NFPA Technical Committee on Electrical Standard for Industrial Machinery (EEI-AAA) NFPA 79 First Draft Meeting (First Draft)

Monday, March 10th to Wednesday, March 12th, 2025
9:00 a.m. – 6:00 p.m. (Eastern)

Public Input No. 28-NFPA 79-2024 [Section No. 1.1.1]

4.10* Cybersecurity

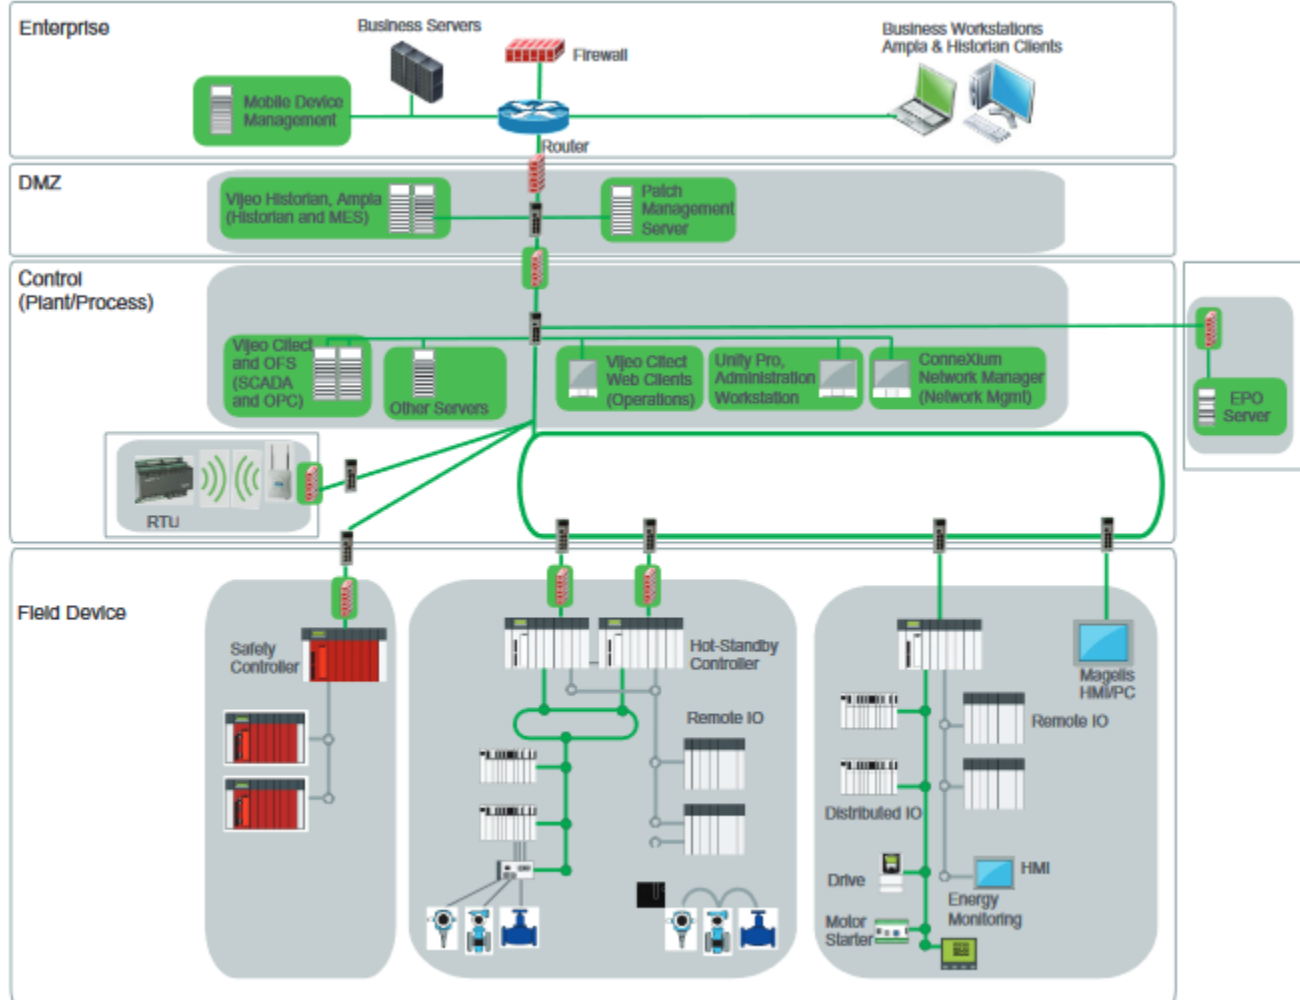
In reviewing the response to the original PI, I still feel that cybersecurity is essential to properly protecting industrial machinery and a consensus standard is the best way to protect these systems in lieu of 51 different requirements from the federal government and the individual states. However, I understand that we need to create a starting point to learn the best methods before setting full requirements.

Cybersecurity should be considered as an aspect of safety and reliability in addition to the other factors affecting industrial machinery. If an attacker can affect the machinery control system, individual sensors or other IoT devices to the point of either preventing normal operation or displaying the appearance of normal operation while failing the system, creates an unsafe condition. The increase in cyber-attacks on industrial, utility, and other installations where industrial machinery can be made to create unsafe conditions. Examples of these unsafe conditions can be changing overcurrent protection rating of a circuit breaker, arc energy reduction settings, SCADA systems, emergency stop functions, motor controllers, or Fire Protection Systems. European Machine Directive is investigating Cybersecurity requirements.

Industrial Machinery that is connected to a communication network and permitted to control any part of the machinery shall be permitted to comply with (1) and (2).

(1) A Cybersecurity Assessment conducted on the connected system determine vulnerabilities to cyber-attacks.

(2) A Cybersecurity Commissioning Certification conducted on the connected system to ensure they are designed against cyber-attacks and known vulnerabilities.

Provide documentation of the assessment and certification to those authorized to inspect, operate, and maintain.

Figure A.4.10.6 System Typical Firewall/Gateway Operation. [72:Figure A.11.7]

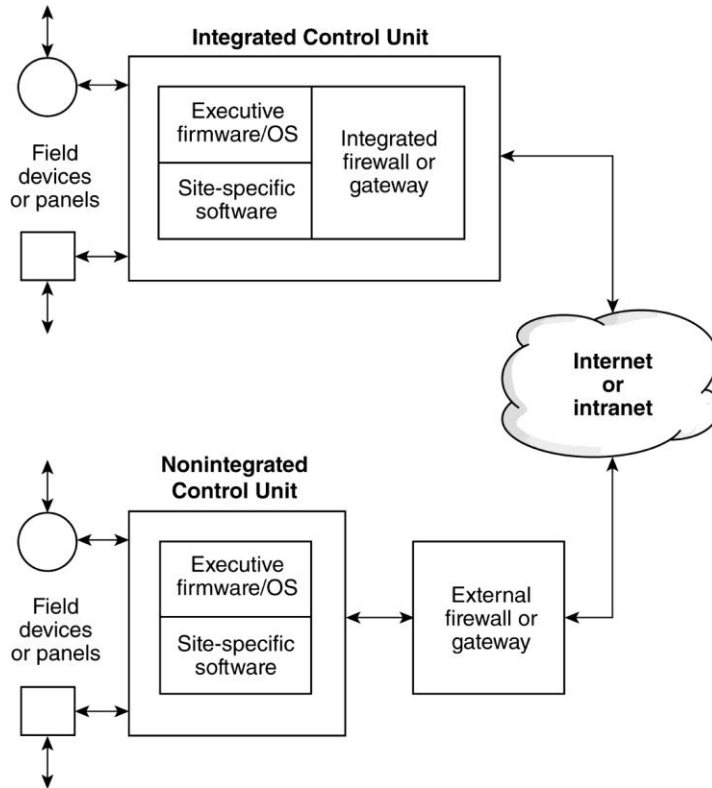
Figure A.4.10.6 depicts typical system typical firewall/gateway operation. Such functionality, when deployed, could take the form of physical hardware, firmware, or both. The firewall/gateway might be physically integrated into the control unit, as shown in the integrated control unit graphic, or a separate device/service that interacts with the control unit, as shown in the nonintegrated control unit. [72:A.11.7]
